MUNICIPAL CORPORATION,  
KARACHI

ORDER UNDER SCH. VI, CHP. XI, RULE 5 (1) OF  
ACT XVII OF 1933.

PLAN SHOWING THE PROPOSED BUILDING ON PLOT No 24 MM I MACHHI MIANI QUARTER SCALE 8' TO 1"

Re:- Plot No 24 M.M.1 Machhi  
Miani quarter, Karachi.

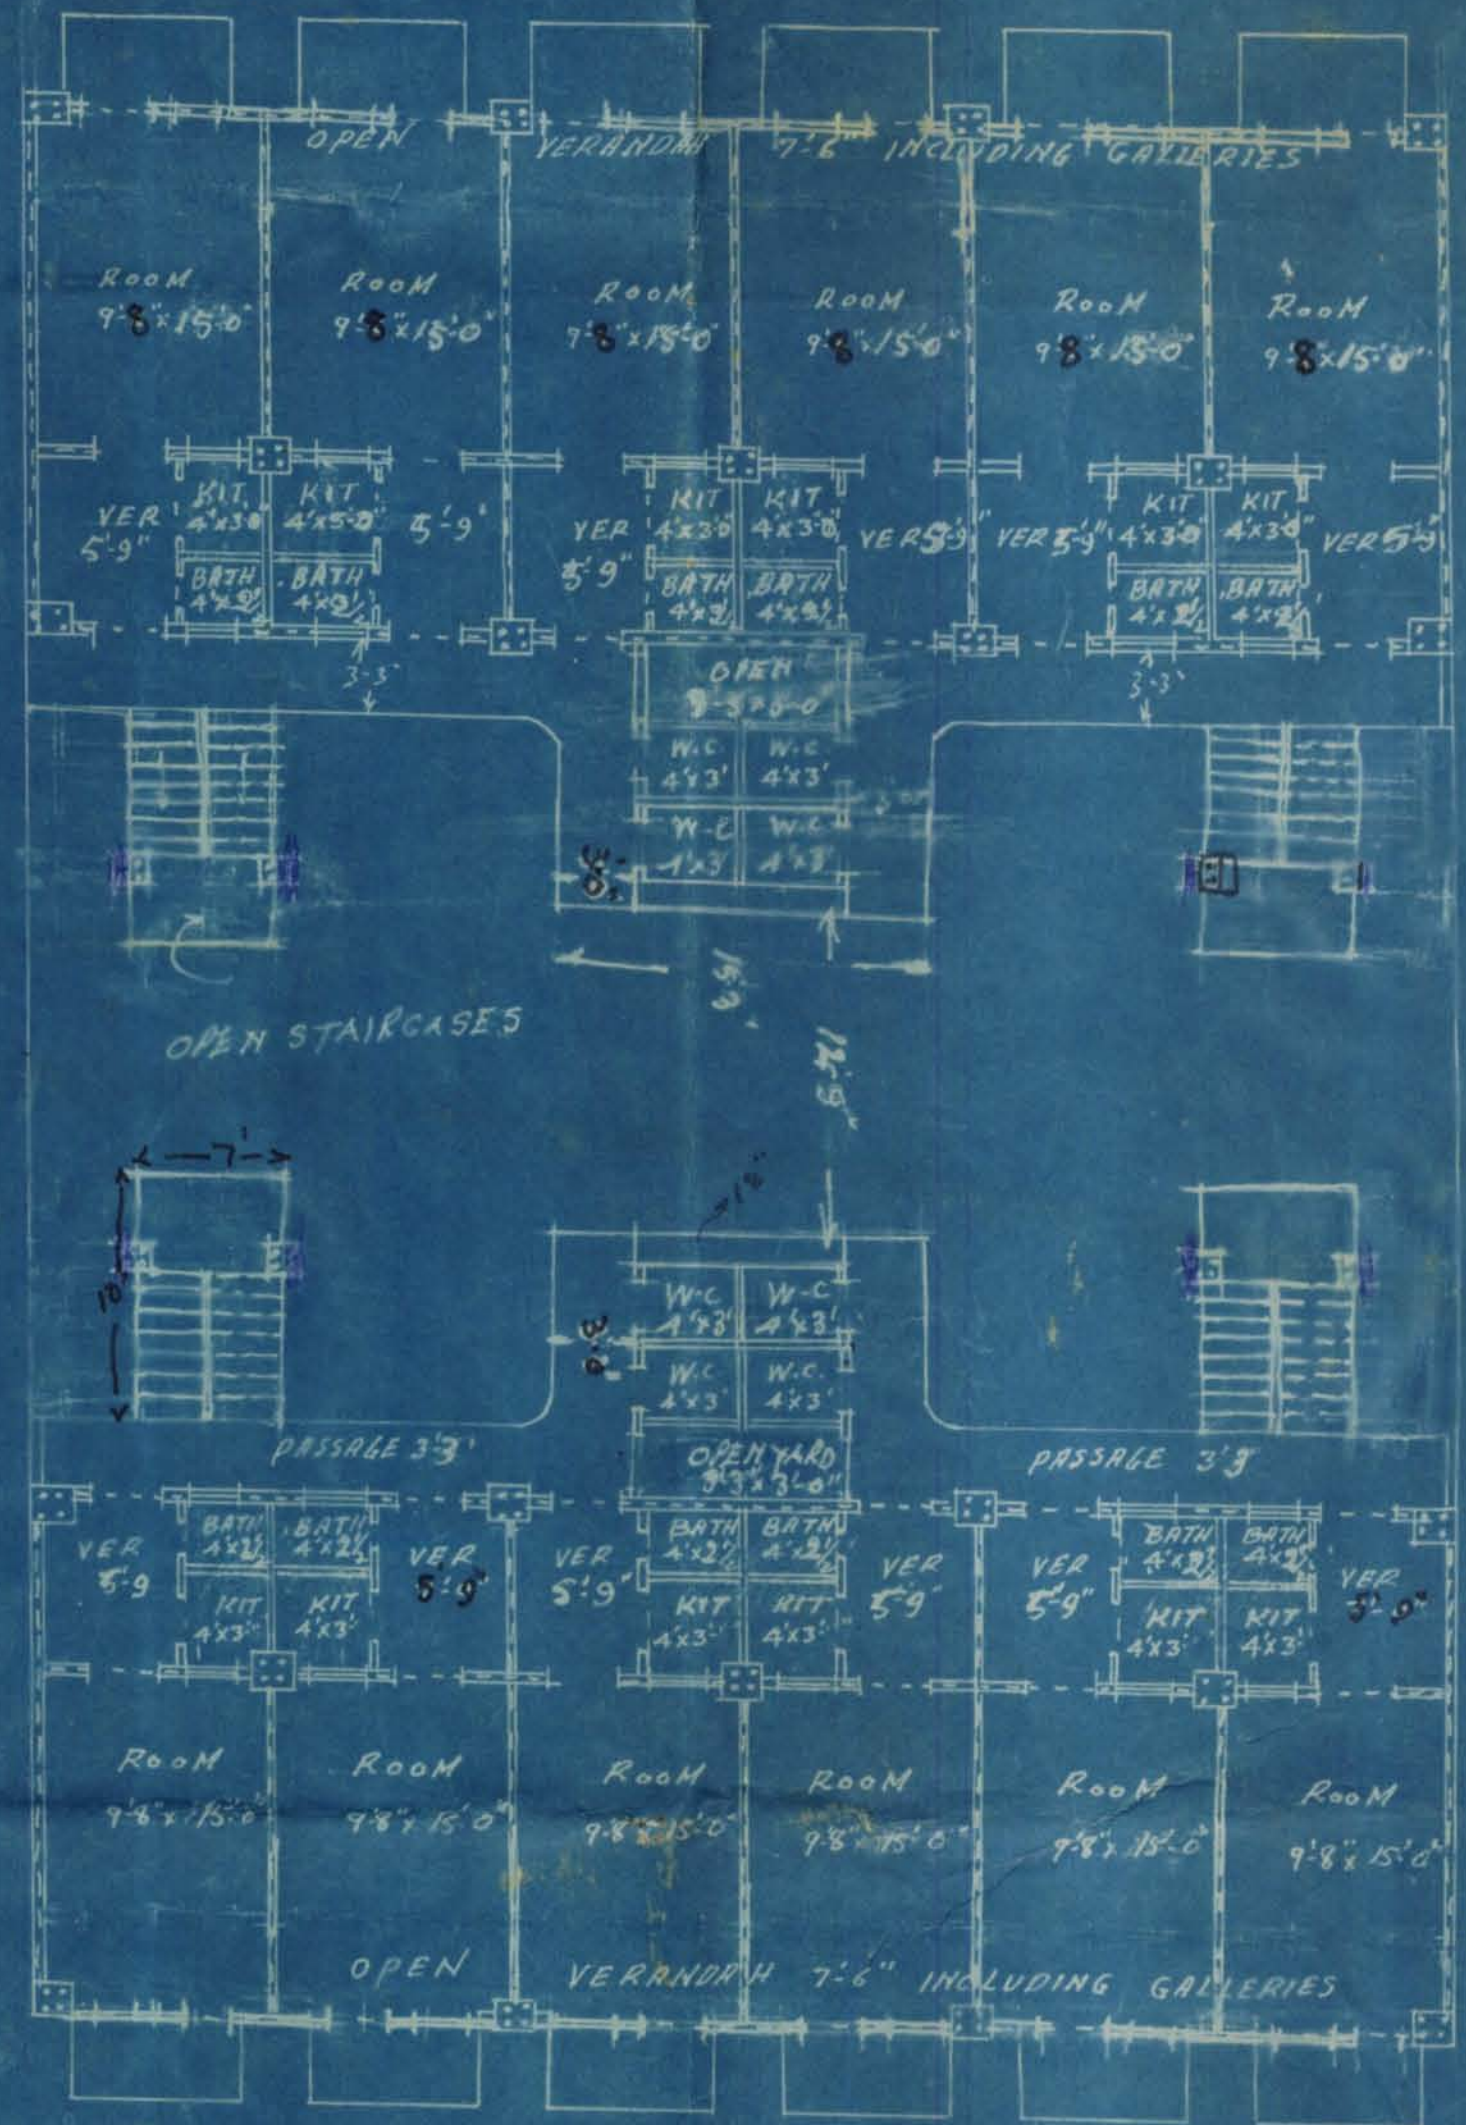
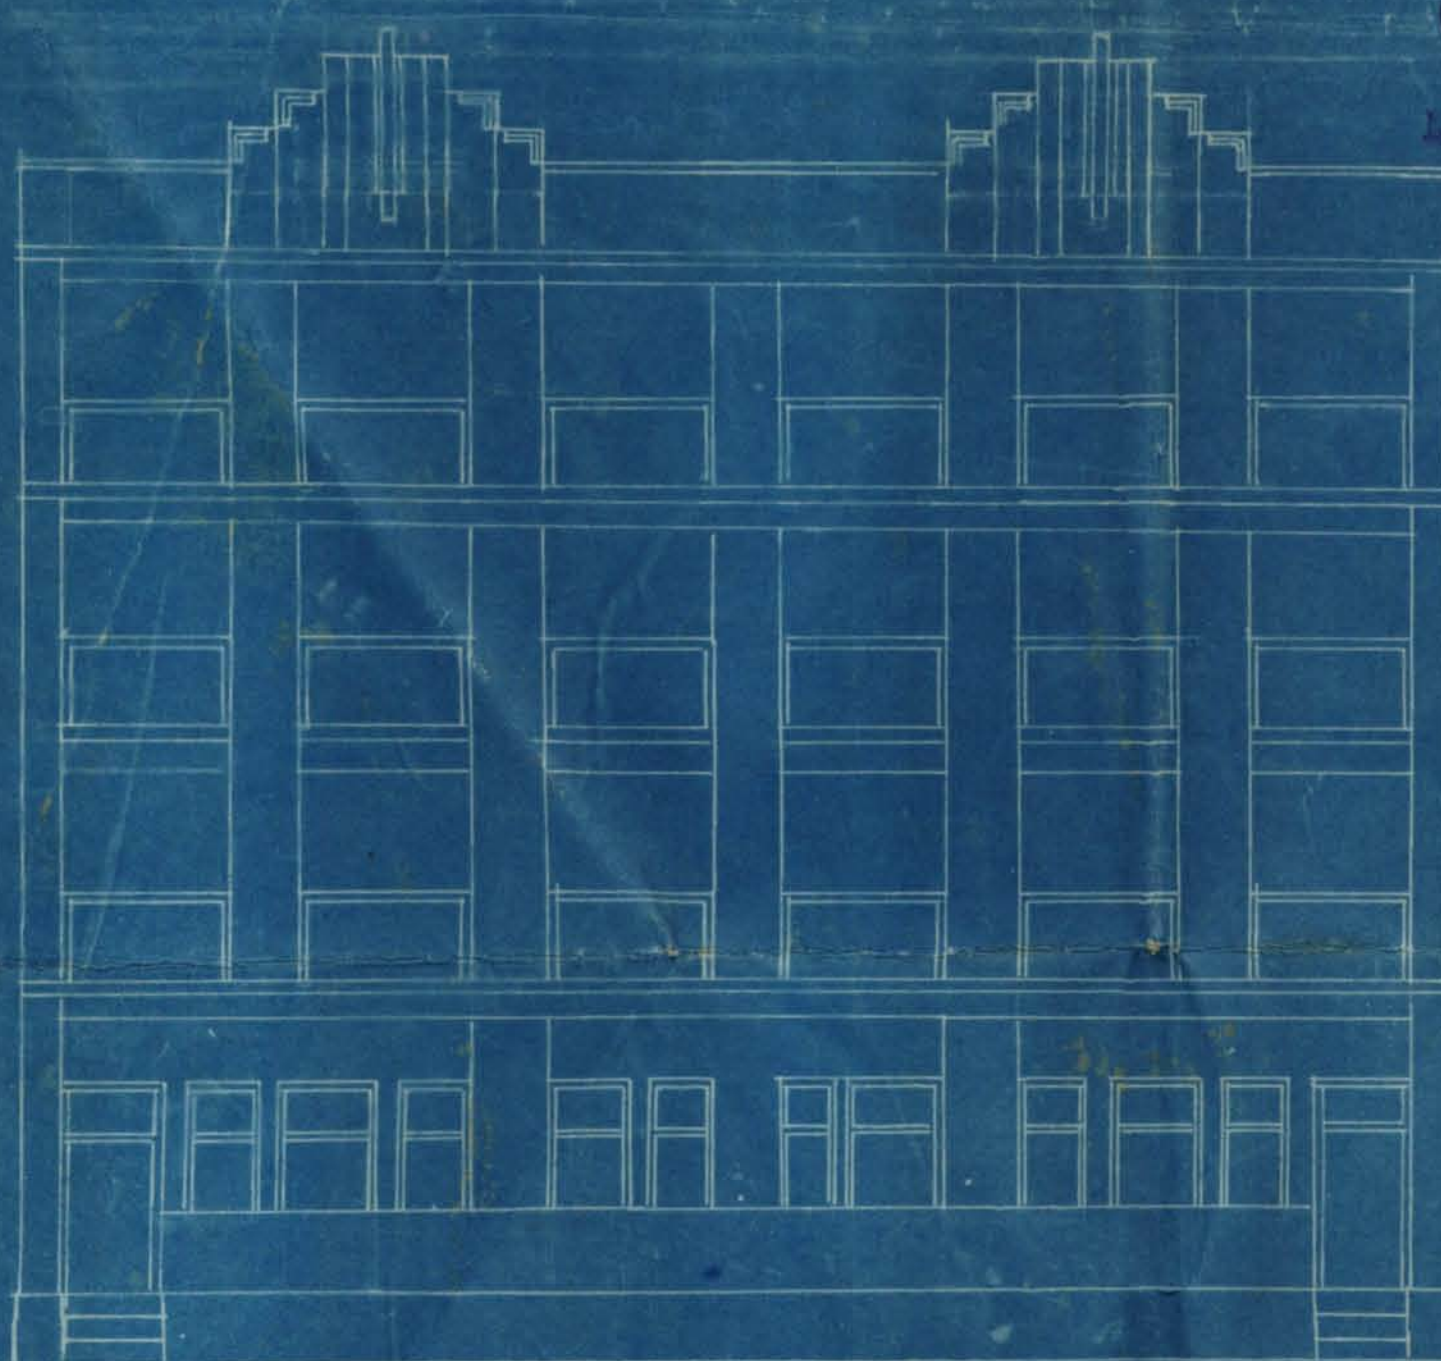
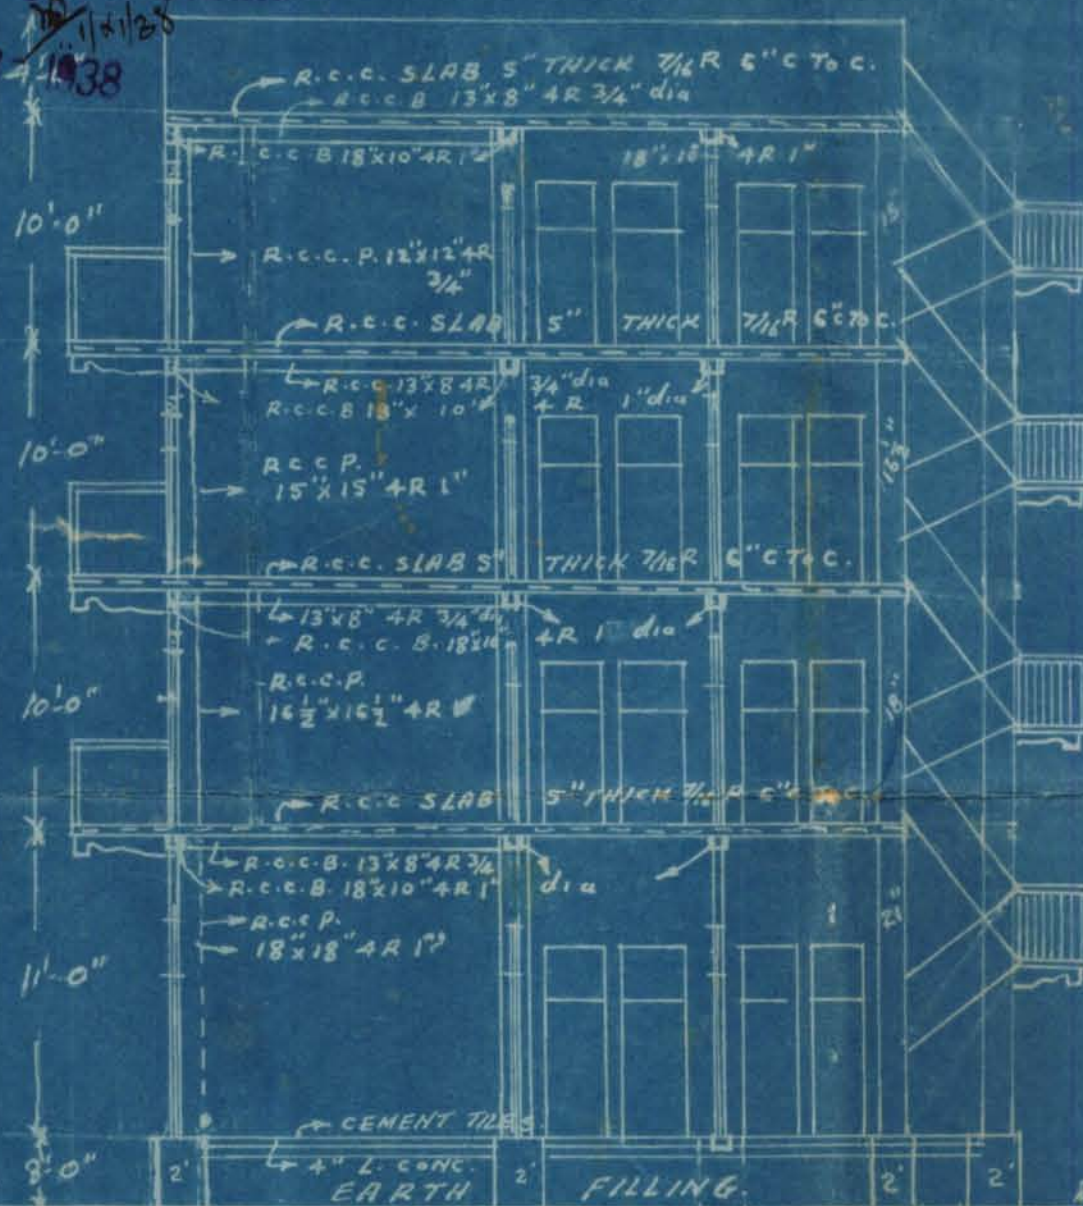
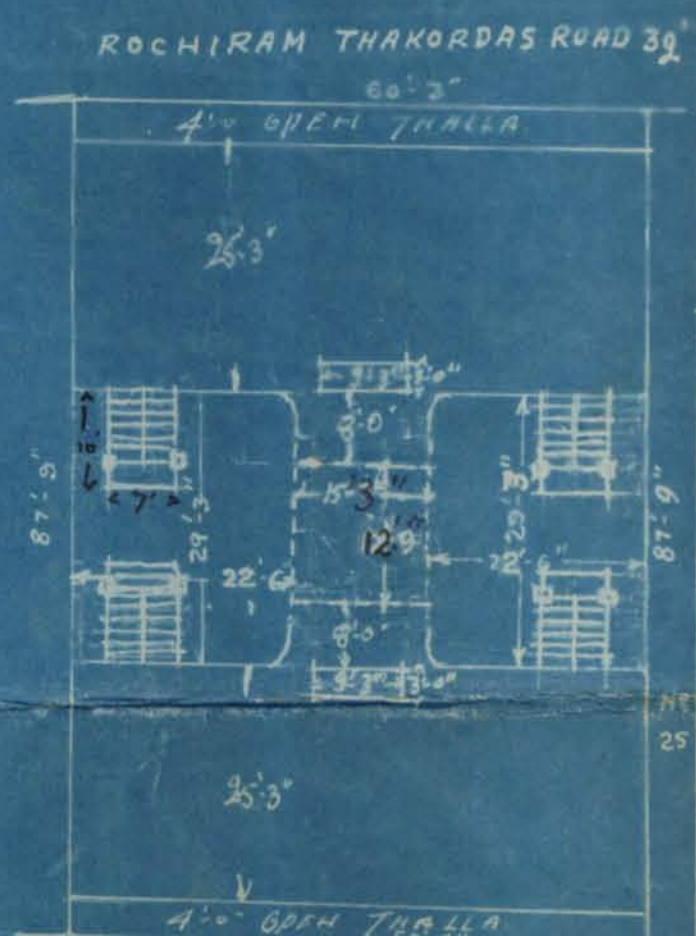
NOTE: PARTITIONS BETWEEN ROOMS AND VERANDAH WILL BE KEPT 7'6" HIGH APPROVED.

PLAN SHOWING THE PROPOSED BUILDING ON PLOT No 24 M M I MACHHI MIANI QUARTER SCALE 8' TO 1"

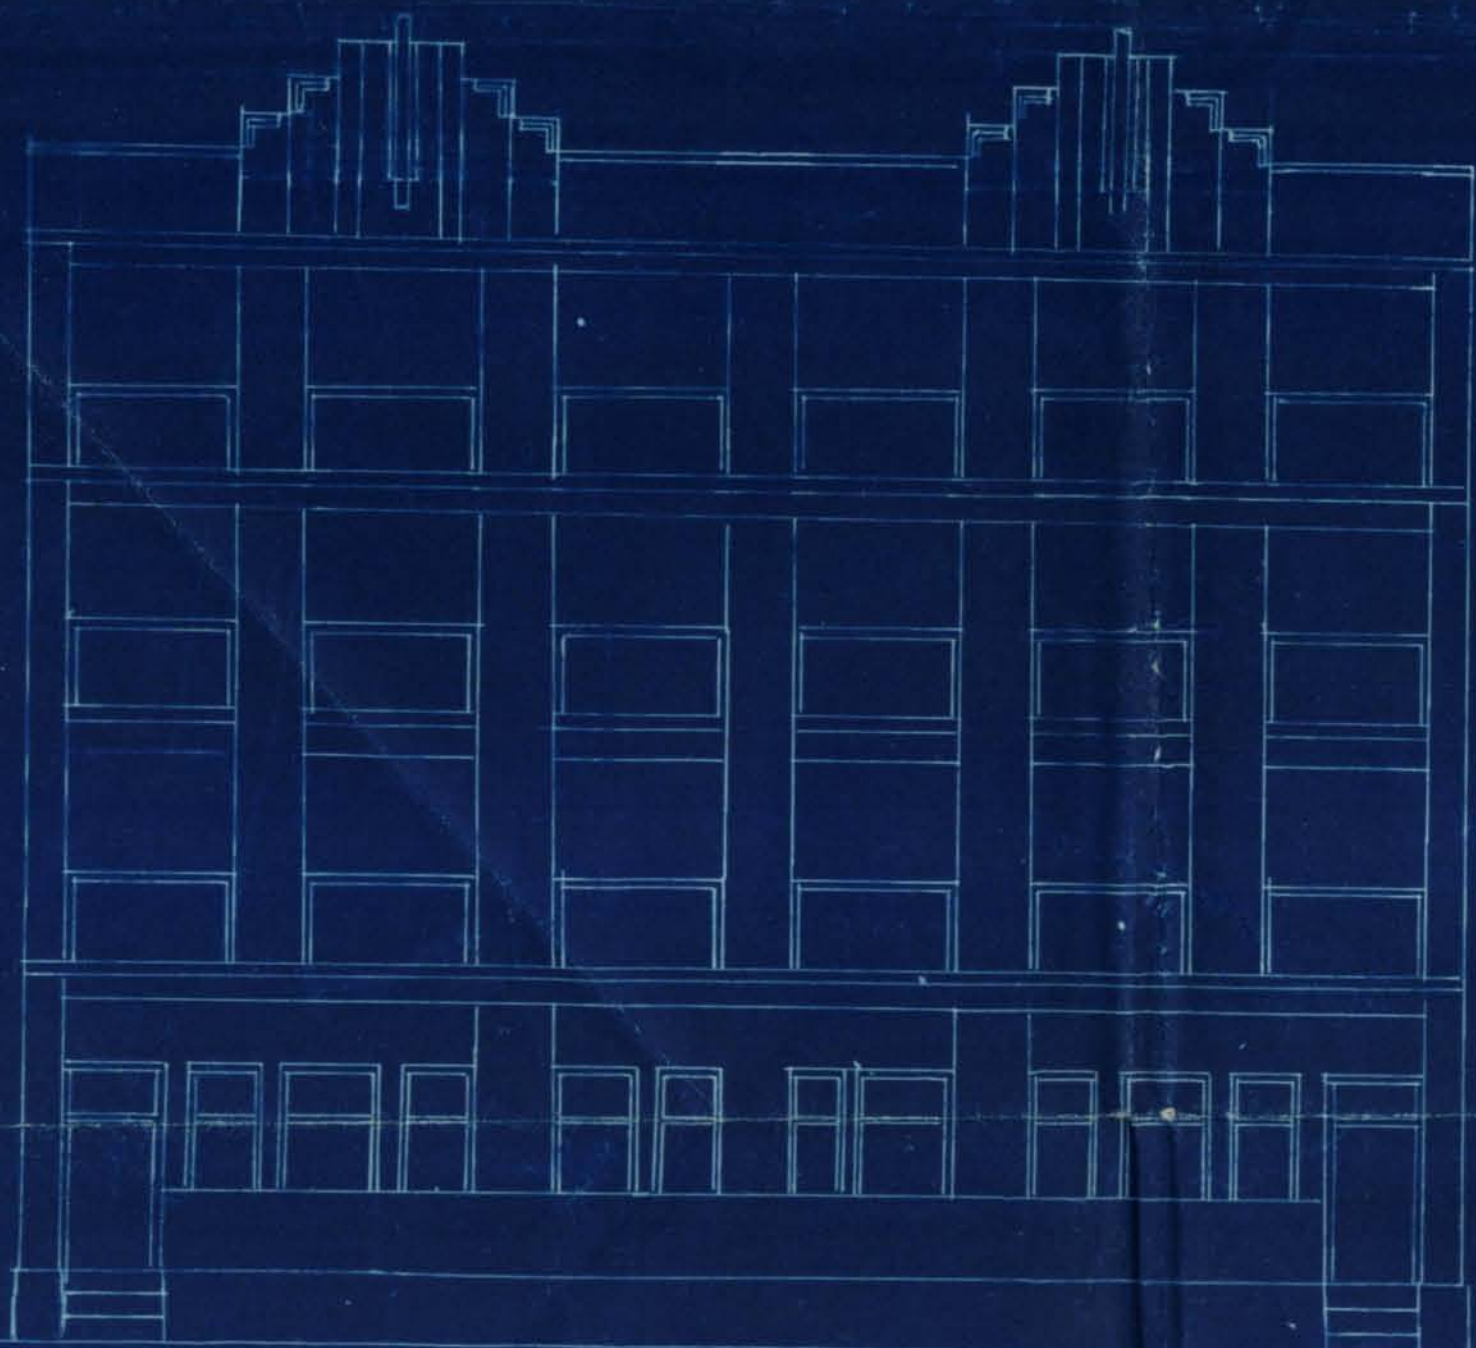
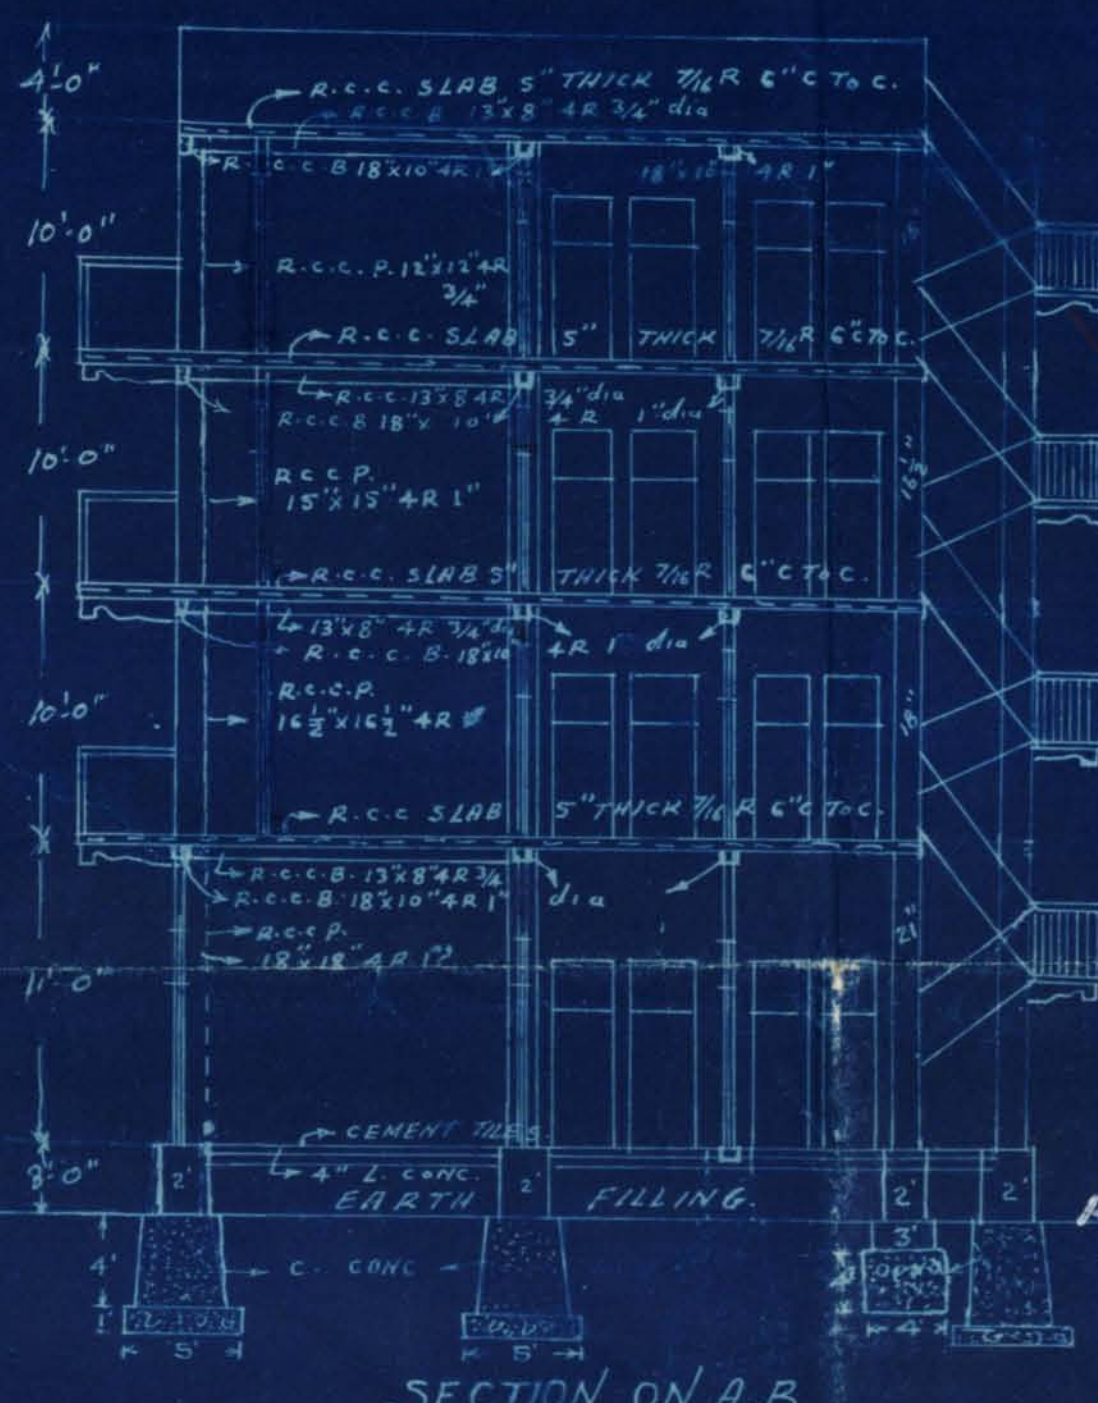
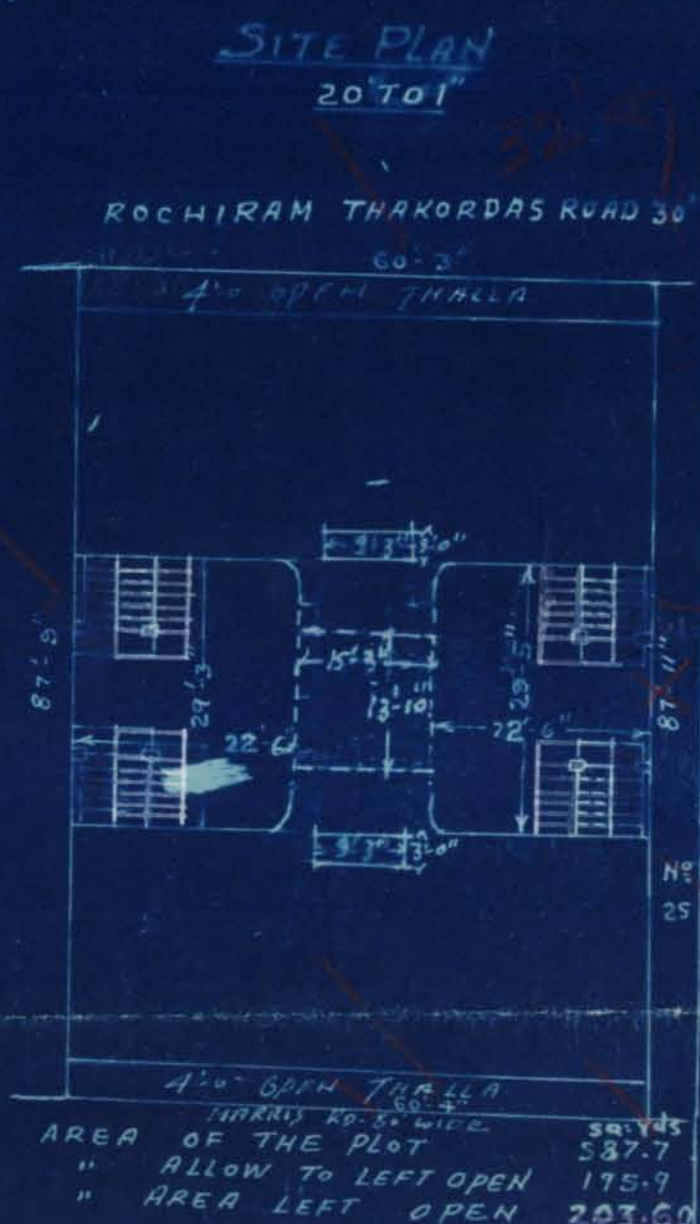
Requirements Nos. 5, 8 & 10 ~~are not~~ of this office  
letter dated 11-6-38 are not complied with; for former  
(i.e. No. 5) Architect is requested to see the Building  
Surveyor.

5. Complied with
- 8 The sizes of beams etc have  
been kept as per standard specifications
10. The partition between the veranda  
& rooms are kept over 7.6"

Note: Partitions between rooms and verandahs will be kept 7'6" high
